Reviewers' comments:

Reviewer #1 (Remarks to the Author):

Review of Descent trajectory reconstruction and landing site positing of Chang'E-4 on Moon's farside

Fig. 6 Elevation variations of the lunar terrain along the CE-3 and CE-4 nadir flight traces. The blue and orange lines represent the elevation variation for the CE-3 and CE-4 nadir flight trace, respectively.

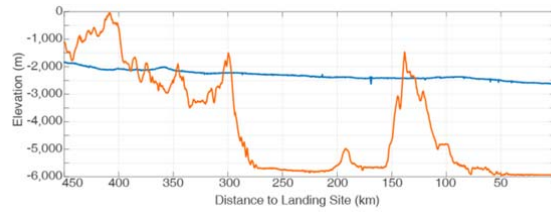
In the discussion section: the comment about the gentle topography (L173) for the Chang'E-4 site compared to the Chang'E-3 site lacked sufficient detail to draw effective conclusions. A 3km variation vs a 6000m (please use the same units) does not seem like a drastic enough change. It seems like there was something significant, but the text was hard to follow. The phrase "avoid the discontinuity" (L176) needs more clarity.

Figure 6: can you please mark the surface level?

The plot combines topography and spacecraft height. Would it make sense to show topography and spacecraft height separately?

Thanks to the reviewer for his meticulous work. In order to draw our conclusions more clearly and effectively, the manuscript has been improved and supplemented accordingly. (1) In Figure 6, elevation variation of the lunar terrain along the CE-3 nadir flight traces is added, and the description is revised. The elevation variation of 3km in the original manuscript refers to the maximum elevation variation of the lunar terrain in the CE-3 pre-selected landing zone, rather than the actual ones along the CE-3 nadir flight traces. It can be seen from Fig. 6, the lunar terrain along the CE-3 nadir flight trace (about 450km) shows a flat, small variation, gradually decreasing from the south to the north with a maximum variation of ~800 m, while the terrain along the CE-4 nadir flight trace shows a large variation with a maximum variation of 6000 m. The difference in elevation variations of the lunar terrain along the CE-3 and CE-4 nadir flight traces is significant.

Figure 6 shows the elevation variations of the lunar terrain along the CE-3 and CE-4 nadir flight traces, which measured from the CE2TMap2015 DEM data. It is not the altitude variation of the detectors. The description in the manuscript has been revised in the manuscript, which makes the meaning of the expression clearer.

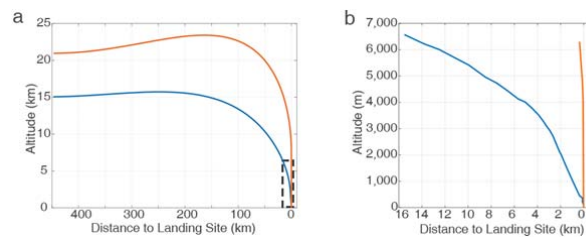
Figure 7 caption

Please add: Altitude is given with respect to final landing site level.

(2)The description in discussion section was revised. The characteristics of the powered descent trajectory of the CE-3 and CE-4 were compared and analyzed according to the difference of the on-orbit control strategies between the two missions. On the other hand, the comparison of powered descent trajectory between the CE-3 and CE-4 was also supplemented.

The manuscript has been revised according to the reviewer's comments. The trajectories in Fig. 7 (a) are indeed designed ones, which used to show the entire powered descent. The trajectory reconstructed in this paper is only the part below the altitude of 6km as showed in Fig. 7 (b).

The manuscript has been revised according to the reviewer's comments. "Altitude is given with respect to final landing site level." is added in the revised manuscript.

Fig.3 Distribution Map of Elevation Deviation Between CE-2 DEM and LOLA DEM

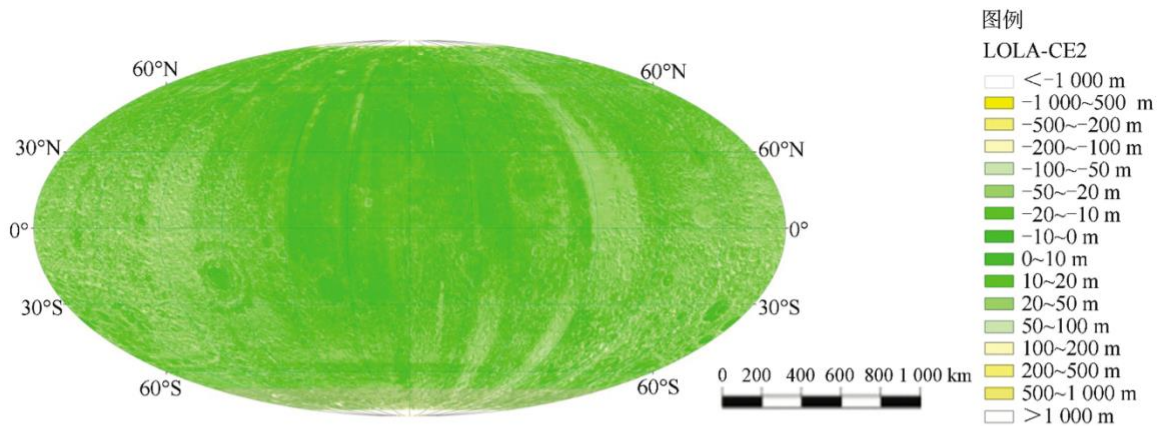
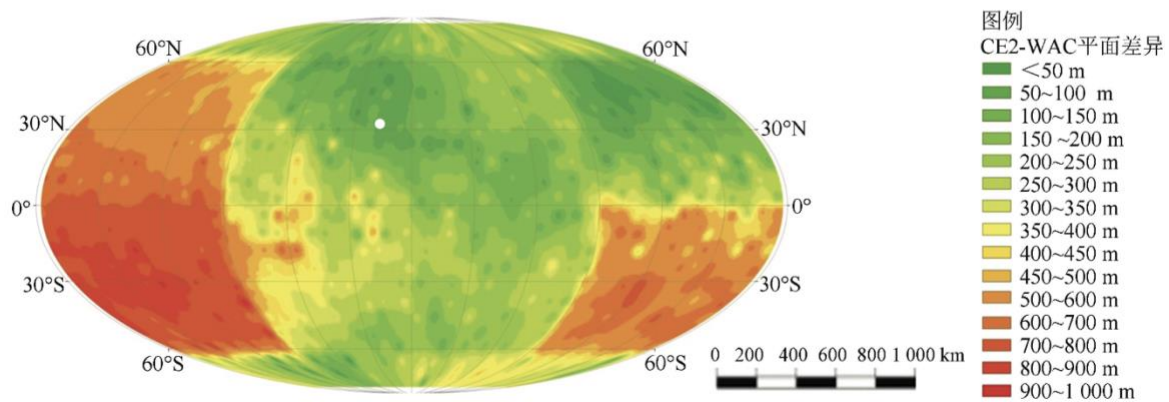
- Reference 21 (http://ch.whu.edu.cn/EN/volumn/volumn_1422.shtml) does seem to be the source of their statement that the LRO and Chang'e 2 laser coordinates agree within uncertainty. Reference 21 also has a figure (pasted below) that shows that either the CE2TMap2015 or the GLD100/LOLA DEMs are grossly in error on the farside, disagreeing by ~500 m horizontally over the CE-4 landing site (and at least that much over most of the much of

the farside). Neither reference 21 nor the paper under review give any rationale for why they assume that CE2TMap2015 is more accurate. Note that Reference 20 is in press and not available to this reviewer.

Figure 3 and 4 from Li, C. L., Liu, J. J., Ren, X., et al. *Lunar Global High precision Terrain Reconstruction Based on Chang'e-2 Stereo Images*. *Geomatics and information Science of Wuhan University*. 43 (4): 486-495 (2018). Note that Google Translate was used to help this non-Chinese reading reviewer read the publication.

Fig.3 Distribution Map of Elevation Deviation Between CE-2 DEM and LOLA DEM

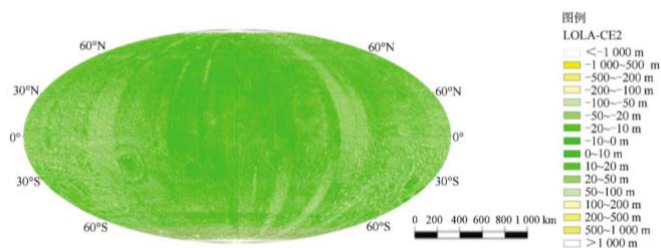
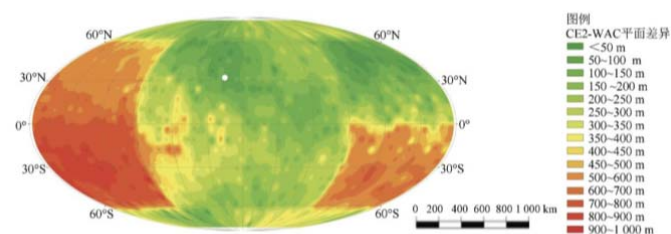
- Reference 21 (http://ch.whu.edu.cn/EN/volumn/volumn_1422.shtml) does seem to be the source of their statement that the LRO and Chang'2 laser coordinates agree within uncertainty. Reference 21 also has a figure (pasted below) that shows that either the CE2TMap2015 or the GLD100/LOLA DEMs are grossly in error on the farside, disagreeing by ~500 m horizontally over the CE-4 landing site (and at least that much over most of the much of the farside). Neither reference 21 nor the paper under review give any rationale for why they assume that CE2TMap2015 is more accurate. Note that Reference 20 is in press and not available to this reviewer.

We sincerely thank the reviewer for his comments. In this study, the location of CE-4 landing site was confirmed on the basemap CE2TMap2015 using photogrammetrically processed images of CE-4 landing camera and navigation camera. CE-4 landing site can be also located in the Lunar Reconnaissance Orbiter (LRO) narrow angle camera (NAC) images, whose relative position to the surrounding terrain is consistent with our results. LRO NAC image of the CE-4 landing site collected on 1 February 2019 (M1303640934LR) is added as Fig.5c.

Our coordinates disagree by more than 400 meters from the LROC team coordinates for the CE-4 lander, which is an objective reflection of the deviation between the two sets of terrain data on the lunar farside. However, it cannot be inferred that the coordinates of CE-4 landing site based on CE2TMap2015 is more accurate (see below for details). Therefore, the description like "...and the landing site position was accurately determined.", "authentic" has been removed from the revised manuscript. Furthermore, the significance of establishing absolute control points on the lunar farside for future lunar exploration missions is discussed. In the method section, the description of LRO terrain data uncertainty and related references are mentioned to avoid the illusion that the absolute coordinates of the CE-4 landing site based on CE2TMap2015 is more accurate.

The revised manuscript shows a discrepancy of 415 meters between our coordinates (177.5991°E, 45.4446°S, -5935 m) and the LROC team coordinates (177.5885°E, 45.4561°S, -5927m) for the CE-4 landing site, which is within the positional deviation range mentioned above and reflects the deviation of the two sets of terrain data on the lunar farside (Co-contribution). Our work does not discuss the absolute positioning accuracy of the two sets of terrain data. The revised manuscript also does not imply whose accuracy of the positioning of the two sets of terrain data on the lunar farside is better. In order to effectively eliminate this deviation, in the discussion section of the revised manuscript, we point out it is a feasible method to establish absolute control points on the lunar farside, which can be an effort in the future lunar exploration program.
